Access Compliance Report

Public Rights-of-Way

(Curb Ramps)

Intersection ID: 21746	Main Street: INTERNATIONAL_DR	Cross Street: PROVIDENCE_RD	Location: NE
ADA ID: 576271F230D5	Ramp Type: BlendTrans1	Initial Pass/Fail: Fail	Overall Compliance: No
		Severity Score: 25

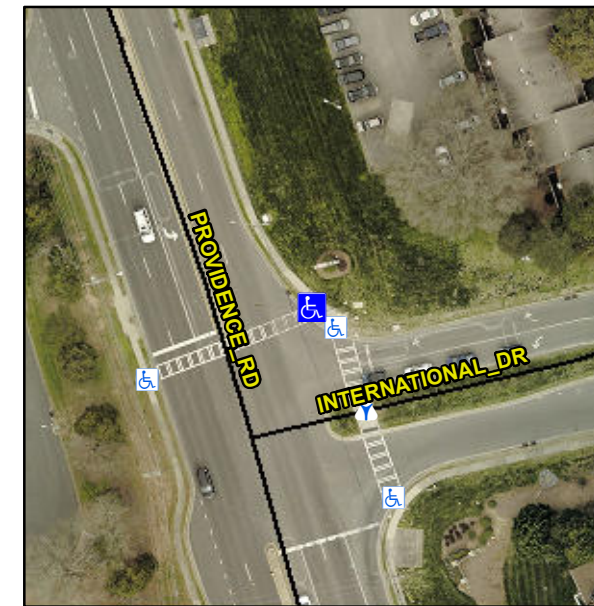
Not Found, R304.5.3

Compliance	Description	Data	Compliance	Description	Data
N/A	Ramp Length (in)	26.0	Yes	BlendTrans Slope (%)	3.6
Yes	Ramp Width (in)	48.0	No	BlendTrans XSlope (%)	10.8
N/A	Flare Type LT	N/A	N/A	Flare Type RT	N/A
N/A	Flare Slope LT (%)	N/A	N/A	Flare Slope RT (%)	N/A
N/A	Flare Traversable LT?	N/A	N/A	Flare Traversable RT?	N/A
N/A	Landing Length (in)	N/A	N/A	DWS Provided?	N/A
N/A	Landing Width (in)	N/A	N/A	DWS Contrast?	N/A
N/A	Landing Slope (%)	N/A	N/A	DWS Length (in)	N/A
N/A	Landing X Slope (%)	N/A	N/A	DWS Full Width?	N/A
N/A	Landing Curb? (Y/N)	N/A	N/A	DWS Offset (in)	N/A
N/A	Shared Landing?	N/A			
N/A	Gutter Ponding?	N/A	N/A	Gutter Slope (%)	N/A
N/A	Gutter Lip Ht (in)	N/A	N/A	Gutter X Slope (%)	N/A
N/A	Painted X Walk1?	Yes	N/A	Painted X Walk2?	N/A
	X Walk 1 Direction	To SW		X Walk 2 Direction	N/A
	X Walk 1 Width (in)	74.0		X Walk 2 Width (in)	N/A
	X Walk 1 Slope (%)	7.8		X Walk 2 Slope (%)	N/A
	X Walk 1 X Slope (%)	7.4		X Walk 2 X Slope (%)	N/A

Remove & Replace Curb Ramp With Two New Directional Ramps or Equivalent.
